UNITED STATES PATENT AND TRADEMARK OFFICE

APPLICATION NO.	FILING DATE	FIRST NAMED INVENTOR	ATTORNEY DOCKET NO.	CONFIRMATION NO.
10/003,404	12/06/2001	Koji Nii	027260-505	5384

Office Action Summary

DETAILED ACTION

FIG. 20

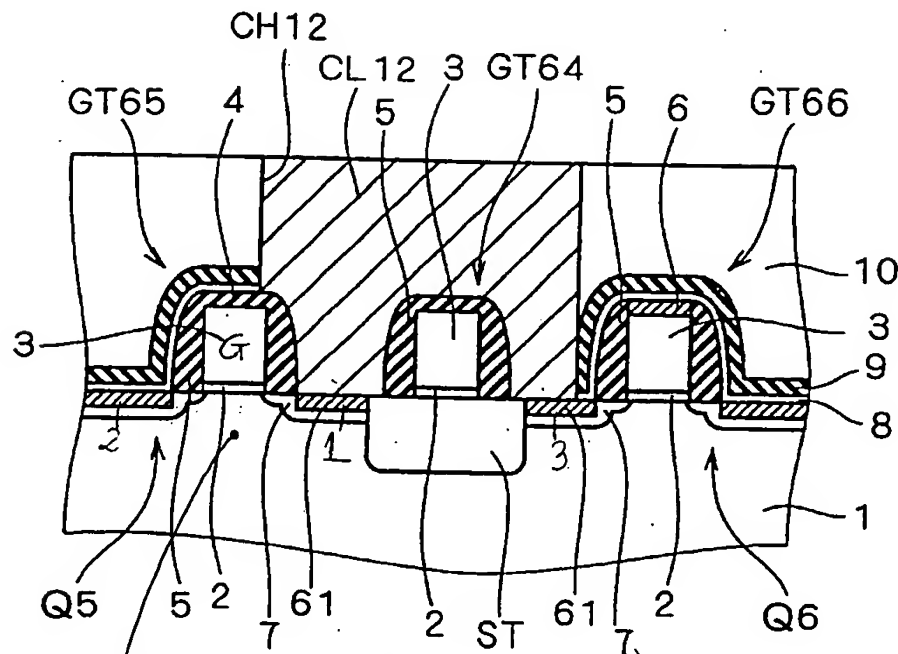
With regard to claim 1, Igarashi et al. disclose a gate electrode 3 formed on a substrate 1 through a gate insulating film 2 lying therebetween; first and second diffused layers formed opposite to each other across the portion of the substrate 1 existing under the gate electrode 3 and having a first conduction type, each having a second conduction type different from the first conduction type of the portion; a contact CL12 formed within a contact hole CH12 on the substrate 1. (Note attachment # 1 of Fig. 20 of Igarashi et al.).

With regard to claim 2, Igarashi et al. discloses the contact CL12 is connected also to the second diffused layer. (Note attachment #1 of Fig. 20 of Igarashi et al.).

separates the first and the third diffused layers each other; wherein the contact CL12 is connected further to the third diffused layer. (Note attachment # 2 of Fig. 20 of Igarashi et al.).

With regard to claim 4, Igarashi et al. disclose a gate electrode 3 formed on a substrate 1 through a gate insulating film 2 lying therebetween; a diffused layer formed on the substrate having first and second diffused portions formed opposite to each other across the portion of the substrate 1 existing under the gate electrode 3 and having a first conduction type, each having a second conduction type different from the first conduction type of the portion of the substrate and a third portion that connects the first portion to the second portion; a contact CL12 formed within a contact hole CH12 on the substrate 1, (Note attachment # 2 of Fig. 20 of Igarashi et al.).

With regard to claim 6, Igarashi et al. discloses another diffused layer formed on the substrate 1; and an isolation area ST formed between the first portion of the diffused layer and the another diffused layer, which separates the first portion of the diffused layer and the another diffused layer, wherein the contact is connected further to the another diffused layer. (Note attachment # 2 of Fig. 20 of Igarashi et al.).
